IOWA DEPARTMENT OF TRANSPORTATION

TO OFFICE:	District 5	DATE:	September 22, 2015
ATTENTION:	Jim Armstrong	REF. :	Lucas County BRF-34-6(79)--38-59
FROM:	Kevin K. Patel		PIN: 13-59-034-010
OFFICE:	Design		
SUBJECT:	Field Exam

A field exam was held on Thursday, September 3, 2015 to review the proposed plan for replacing a bridge on U.S. 34 over White Breast Creek, 1.6 miles east of east junction with U.S. 65.

No plans are included in this submittal; however, the field exam plan with comments may be viewed as PDF files at: `pw:\projectwise.dot.int.lan:PWMain\Documents\Projects\5903401013\Design\D2Submittal\D2_59034079_Plan.pdf`

268'-0 x 44'-0 PRETENSIONED PRESTRESSED CONCRETE BEAM BRIDGE

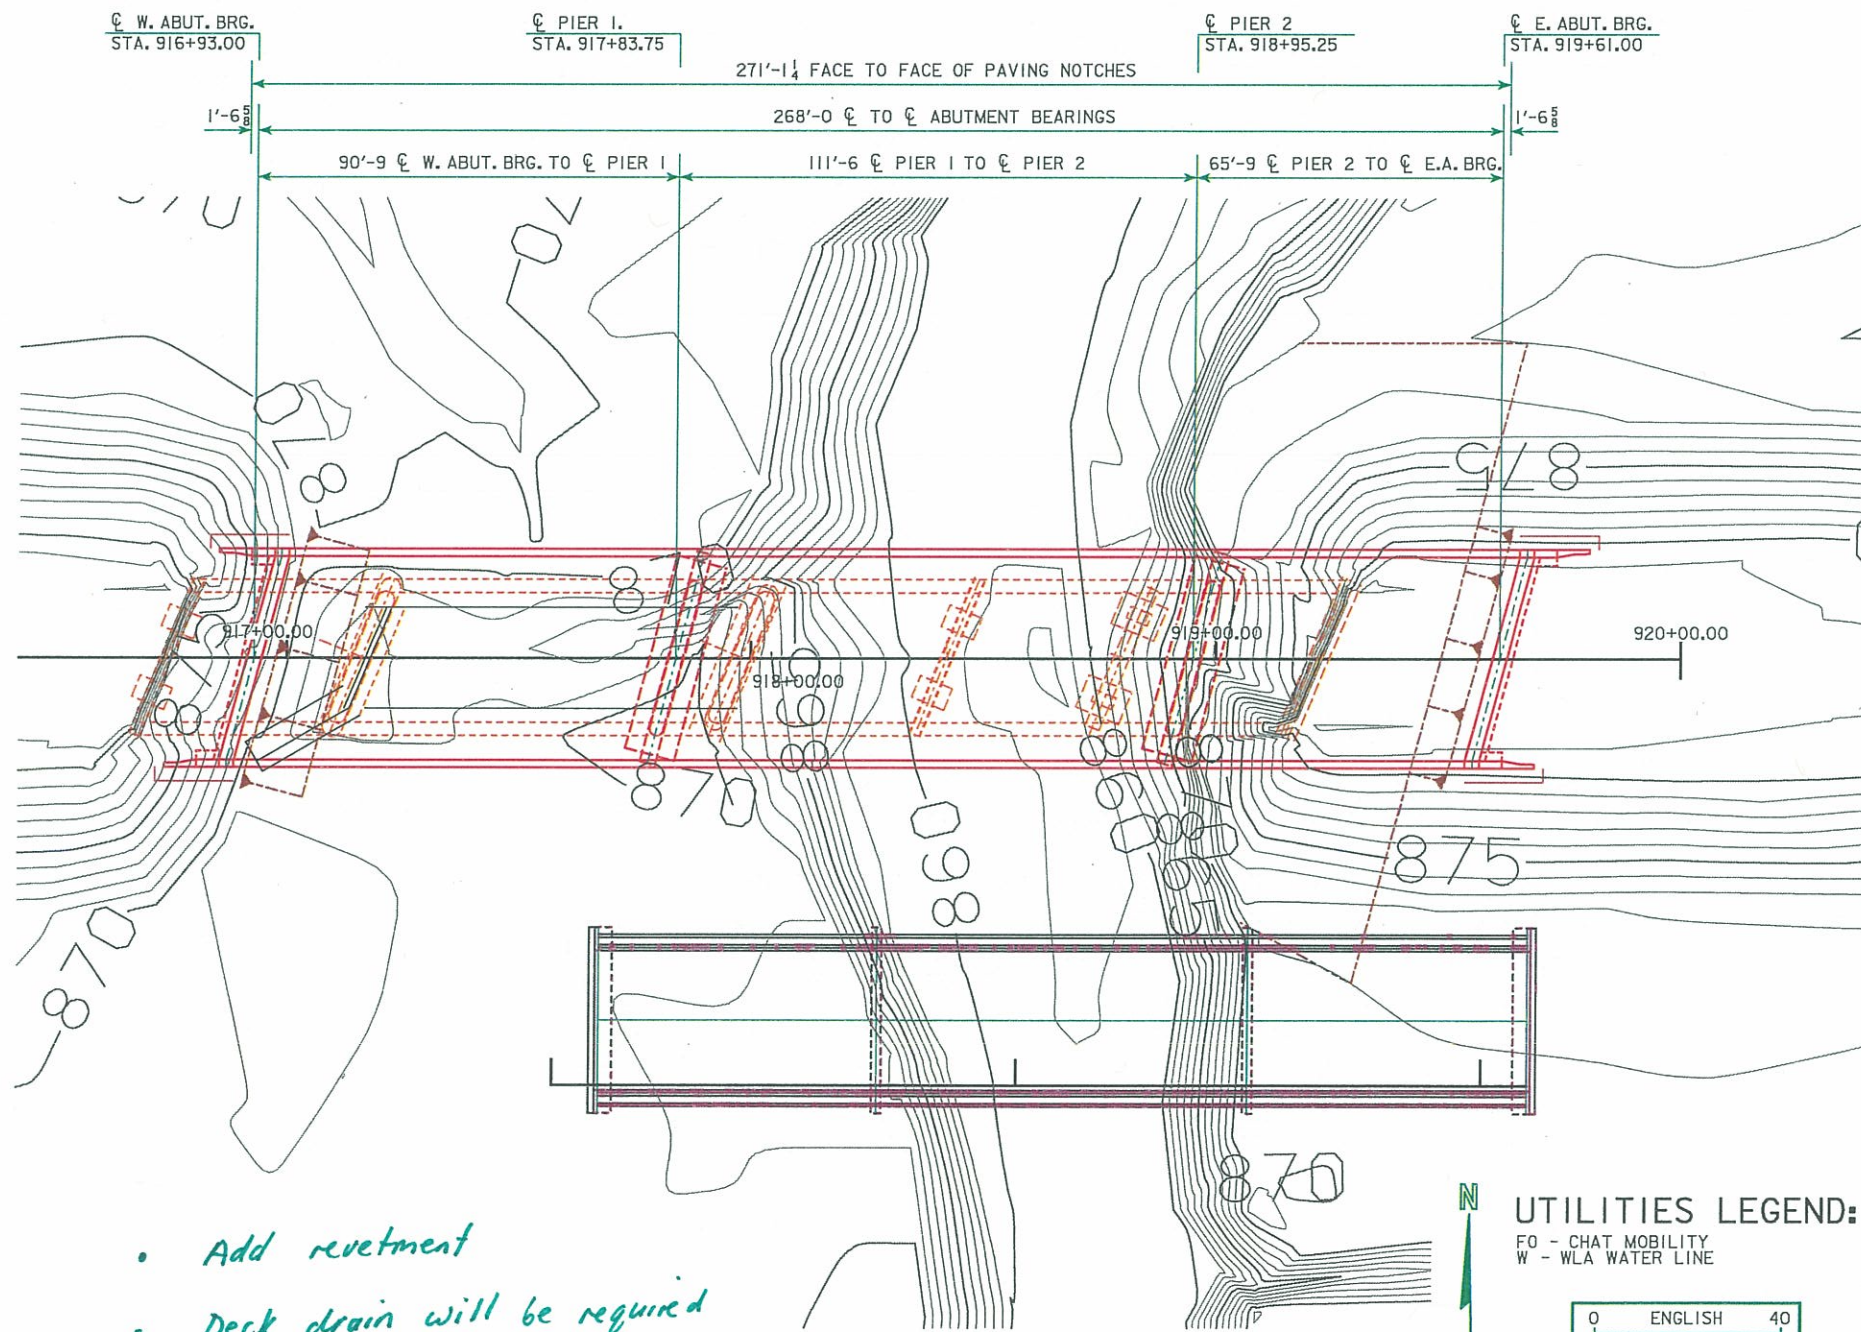
- Add revetment
- Deck drain will be required

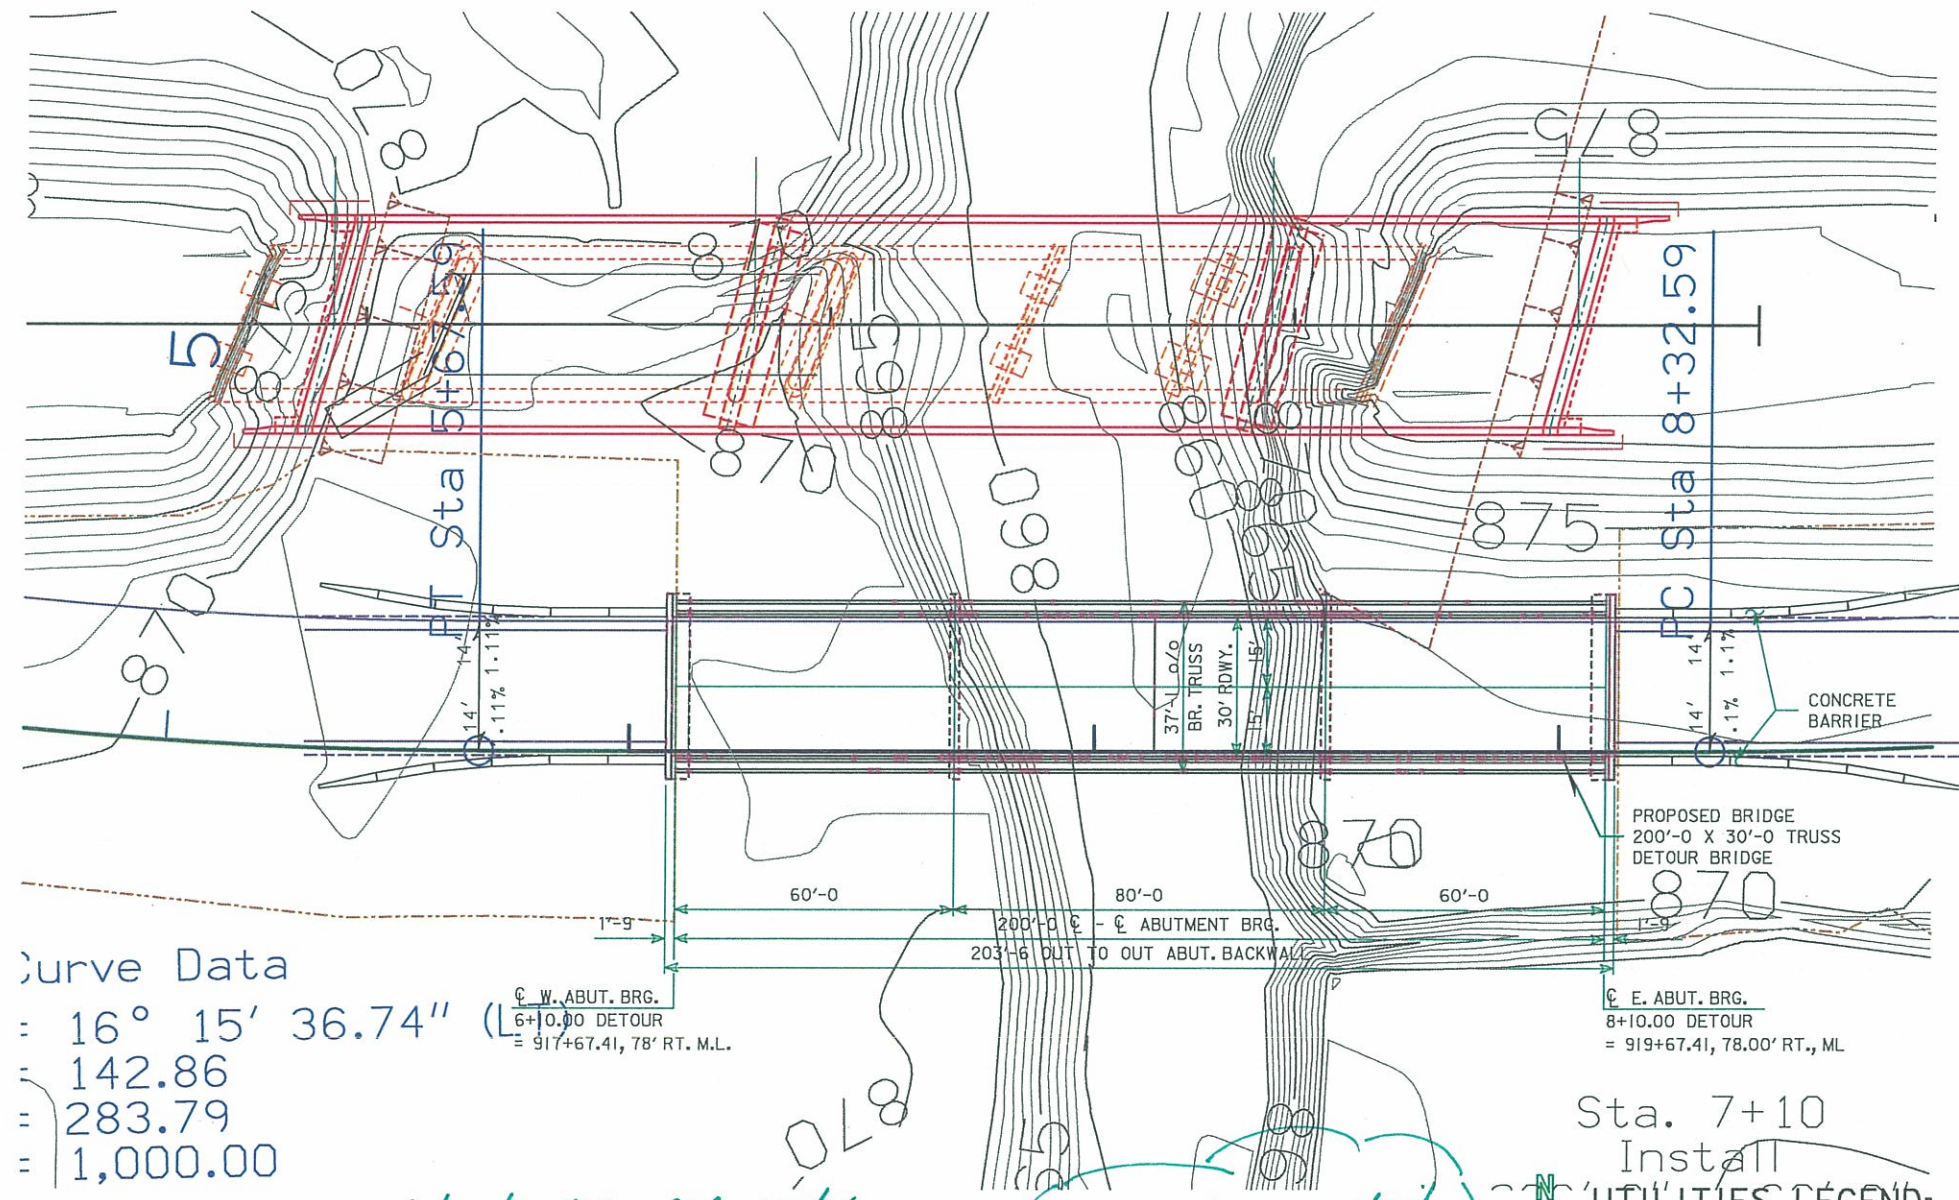
Relocate rip-rap under detour bridge to new bridge

Review how guardrail will attach to temp. bridge
